Aftertreatment Diesel Exhaust Fluid (DEF) Tank, Level Sensor, Replacement

V-258-002

(Aug 2023)

All Cummins powered Volvo Trucks USA 2013 to USA 21 Using the 70-liter DEF tank

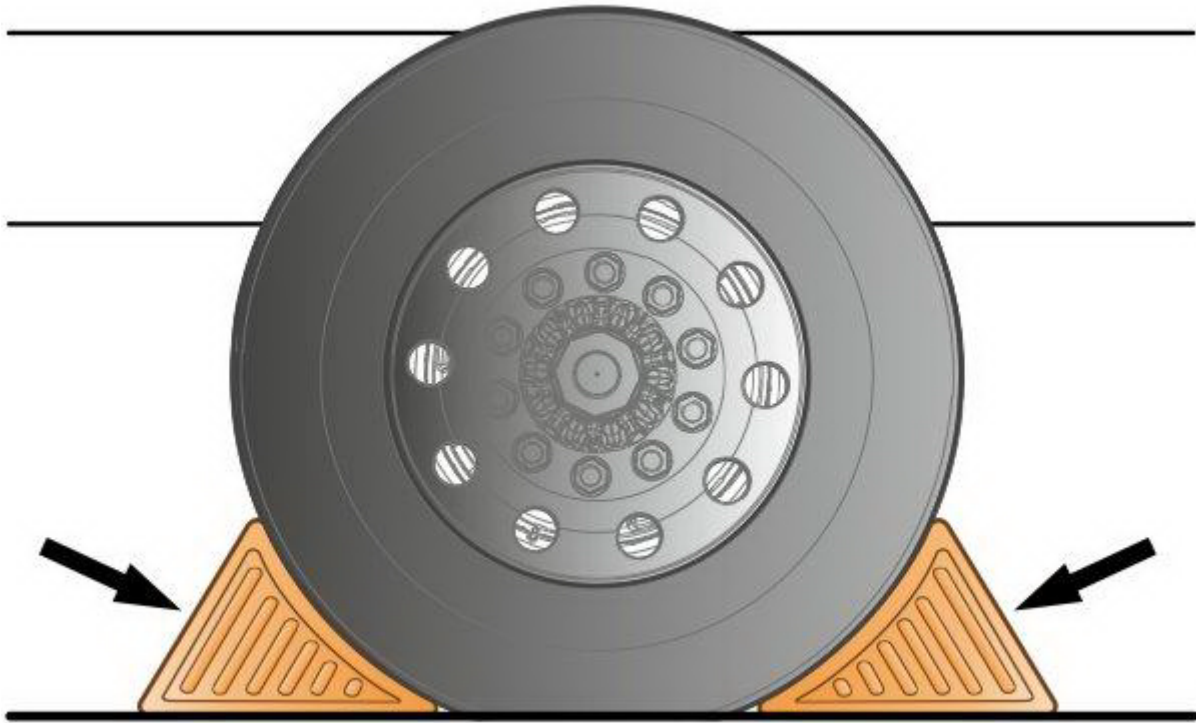
Volvo trucks now offer an updated UQLS to improve functionality and reliability. The new sensor will be a direct replace except for a jumper harness used to plug the new sensor to the existing chassis harness connector. Follow the instructions below to install the new UQLS and its jumper harness.

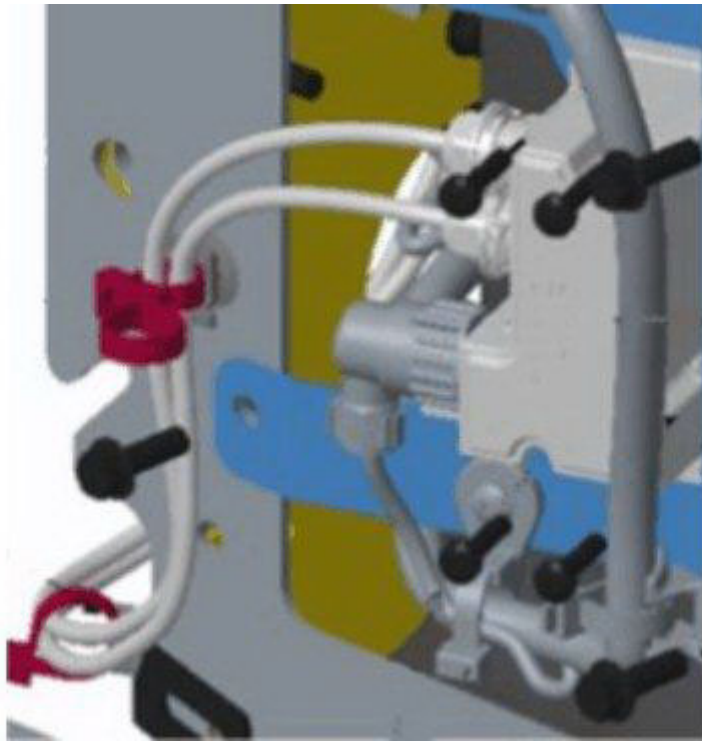
30. Remove the four bolts securing UQLS module.
31. Remove the ties securing the sensor tubes.

32. Loosen the clamp holding in the sensor.
33. Remove the level sensor.

34. Install the new sensor **24135997**.

Note: The new UQLS sensor no longer uses the external module and requires a jumper harness.

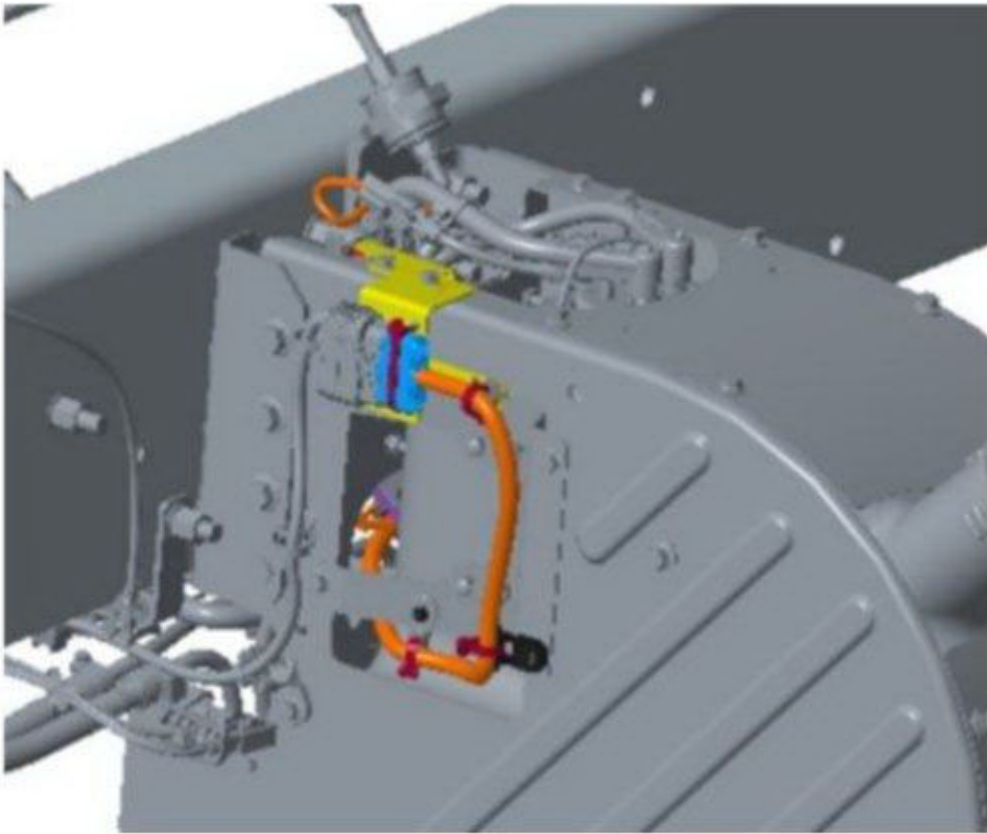
36. Remove the old bracket.

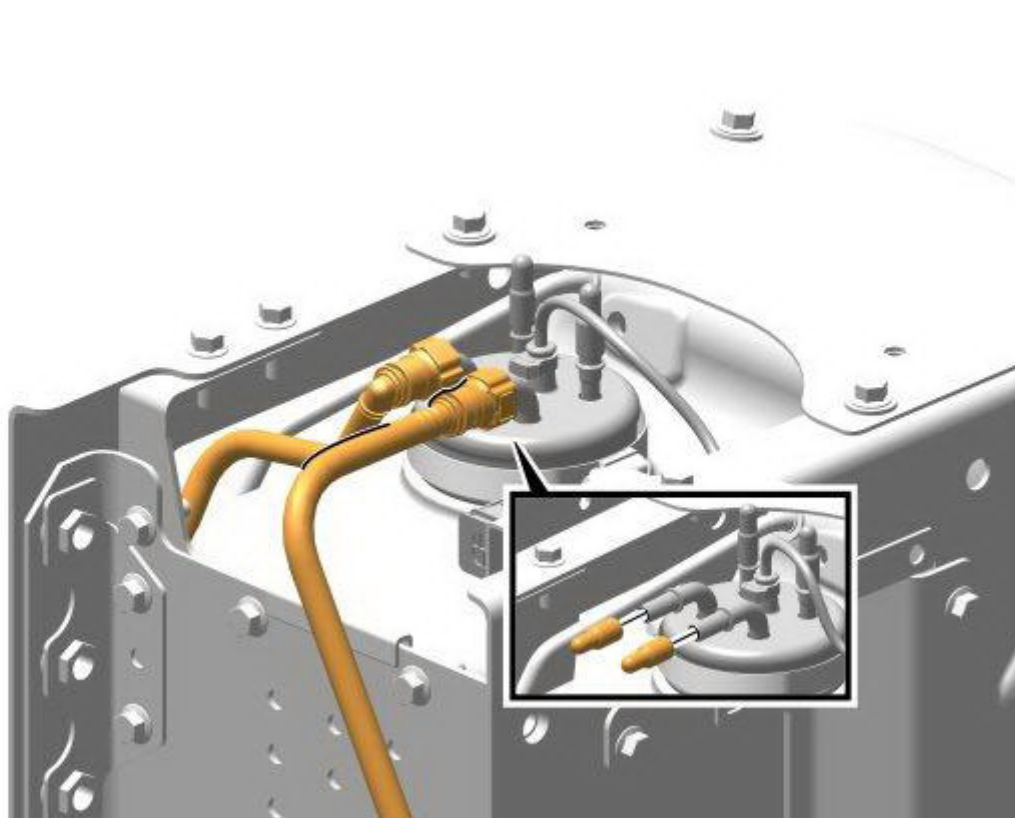
37. Install the new bracket **23933319** and secure using old hardware.

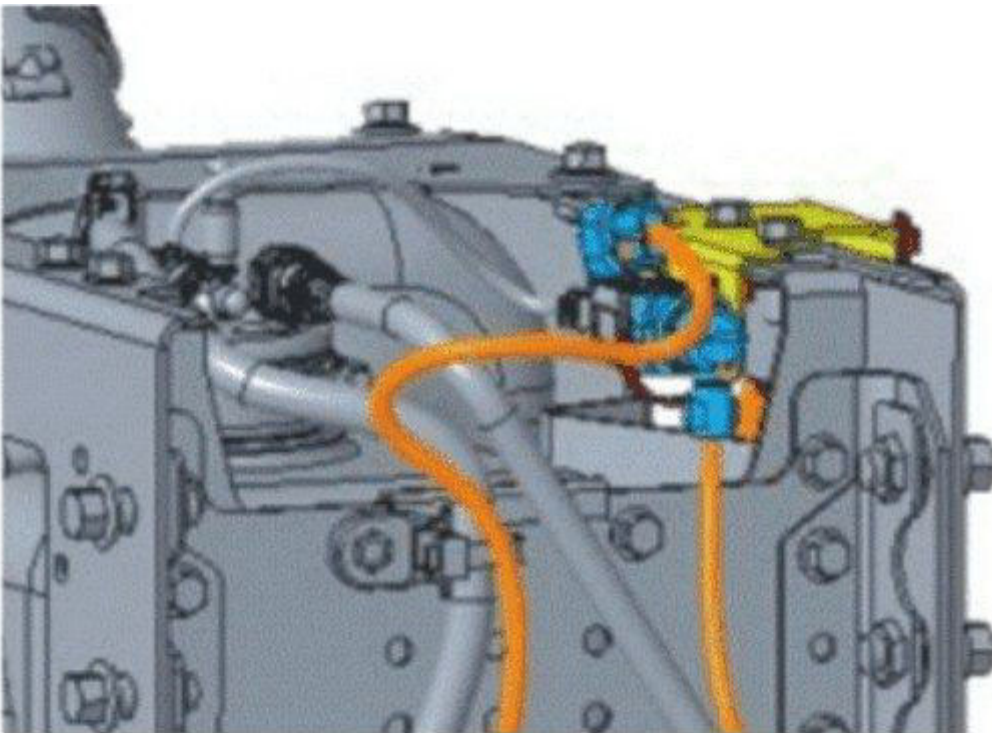
49. Connect the jumper harness **24399920** to the chassis harness and secure using cable ties.

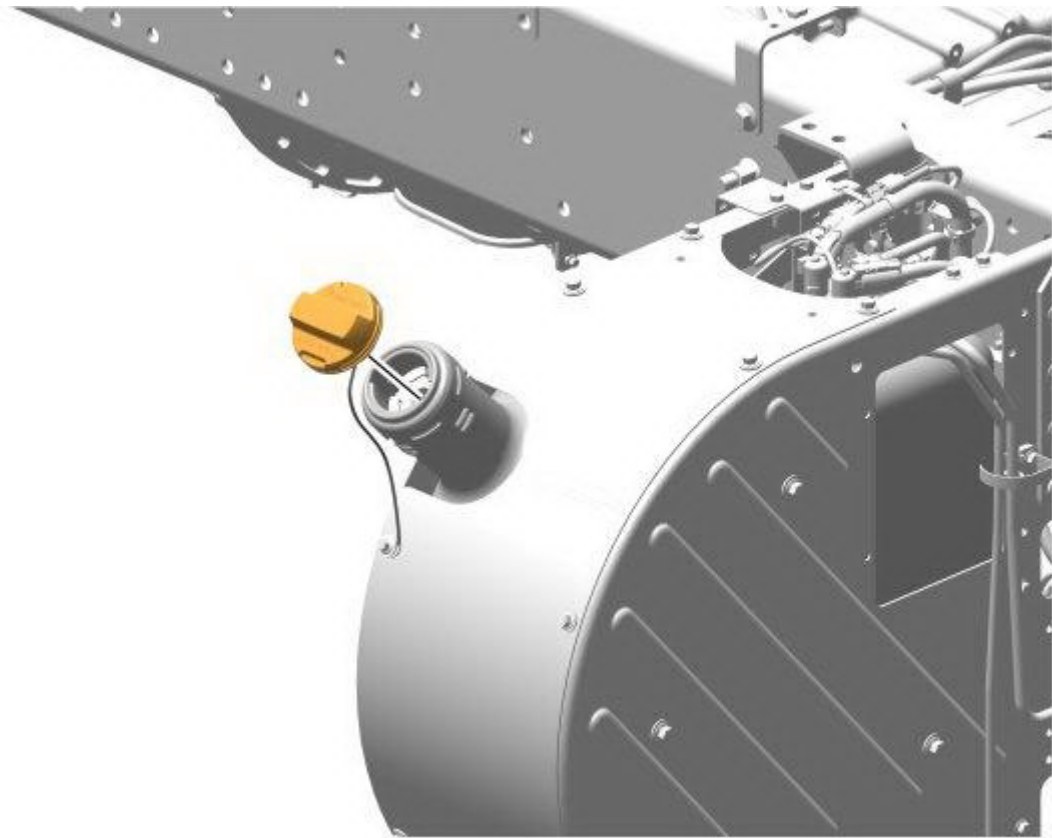
50. Connect the jumper harness **24399920** to the sensor and secure connector and jumper harness to the bracket using cable ties.
